**PLANNING BOARD  
PORTSMOUTH, NEW HAMPSHIRE**

**September 15, 2022**

To: Planning Board  
From: Beverly Mesa-Zendt, Planning Director  
Stefanie L. Casella, Planner  
Date: September 9, 2022  
Re: Recommendations for the September 15, 2022 Planning Board Meeting

The Planning Board, at its regularly scheduled meeting February 18, 2021, considered this application for Preliminary and Final Subdivision approval for a two-lot subdivision located on a private road currently known as Patricia Drive. Subsequent to the Planning Board approval the following actions were taken:

**PGP**  
SHT. 4 of 10

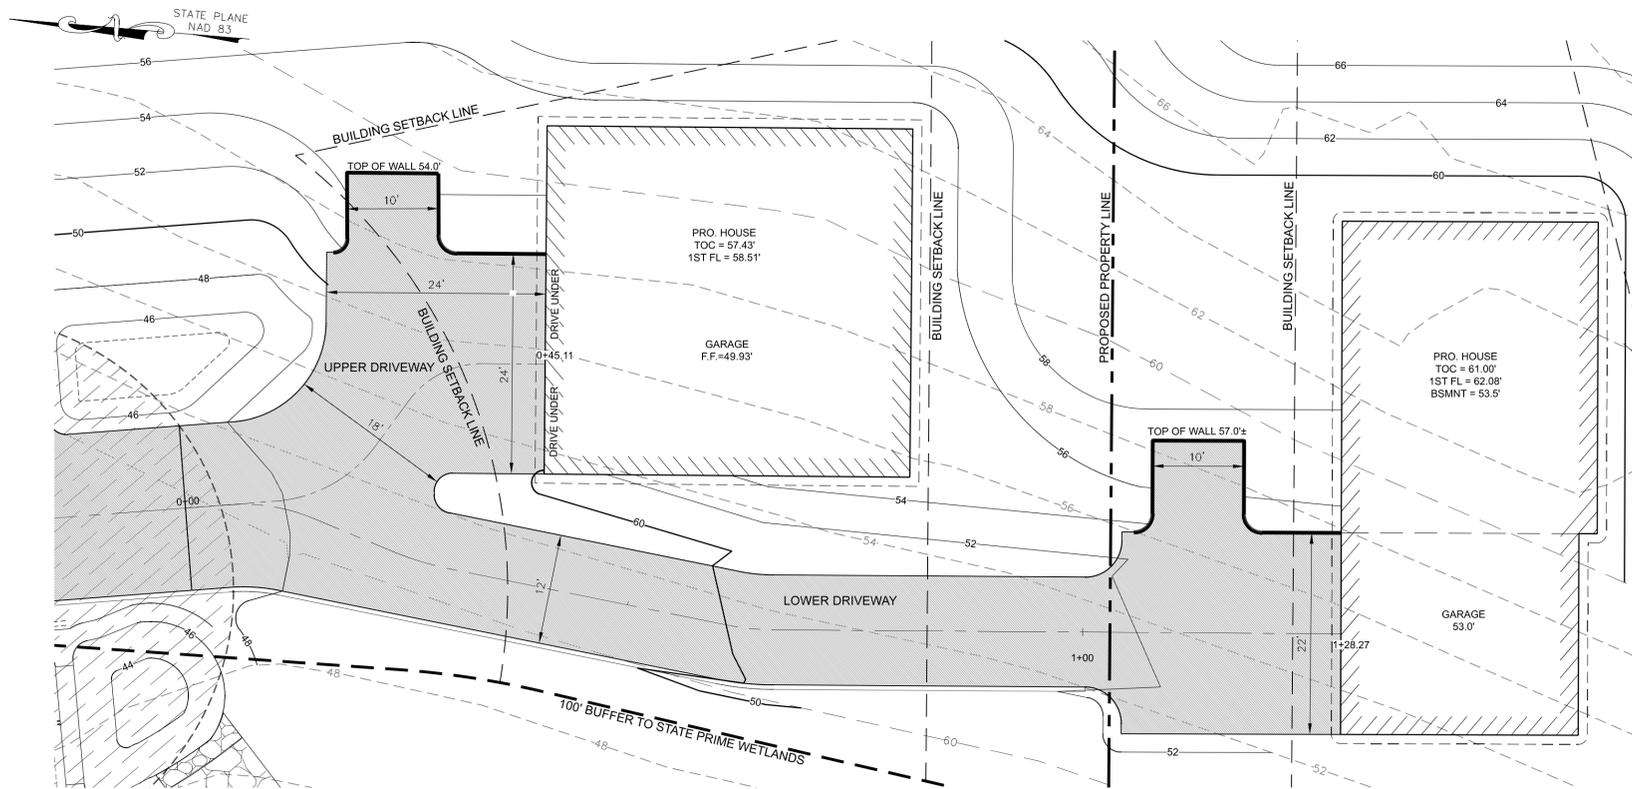
- 2.1) On Plan Sheet 4 – Update contractor’s note to remove asphalt berm on Martha’s Terrace to be removed. **CONDITION MET - NOTE UPDATED AS REQUIRED.**

- 2) To grant Preliminary and Final Subdivision approval with the following stipulations:
  - 2.1) On Plan Sheet 4 – Update contractor’s note to remove asphalt berm on Martha’s Terrace to be removed.

### TYPICAL SECTION - RAIN GARDEN DETAIL

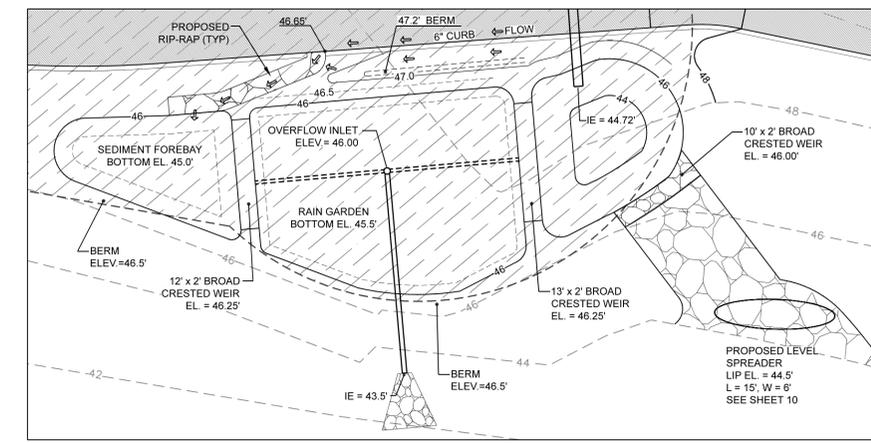
- 2.4) Sheet 9, add to drainage easement note in detail that the easement is to the “City of Portsmouth”
  - 2.5) Rain garden design and detail shall be reviewed and approved by DPW.

- 2.4) Sheet 9, add to drainage easement note in detail that the easement is to the “City of Portsmouth”. **CONDITION MET - NOTE REVISED.**
- 2.5) Rain garden design and detail shall be reviewed and approved by DPW. **CONDITION MET.**
